Access Compliance Report

Public Rights-of-Way

(Curb Ramps)

Intersection ID: N/A	Main Street: STYLE_LN	Cross Street: OUTLETS_BV	Location: NE
ADA ID: 4BE82C1CD7B4	Ramp Type: Perp	Initial Pass/Fail: Fail	Overall Compliance: No
		Severity Score: 22.5

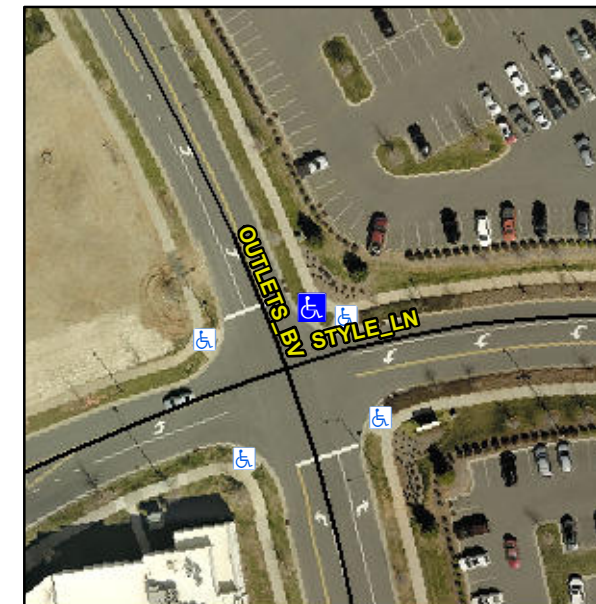
Not Found, R304.5.1, R304.2.2, R304.5.3

Remove & Replace Entire Ramp.
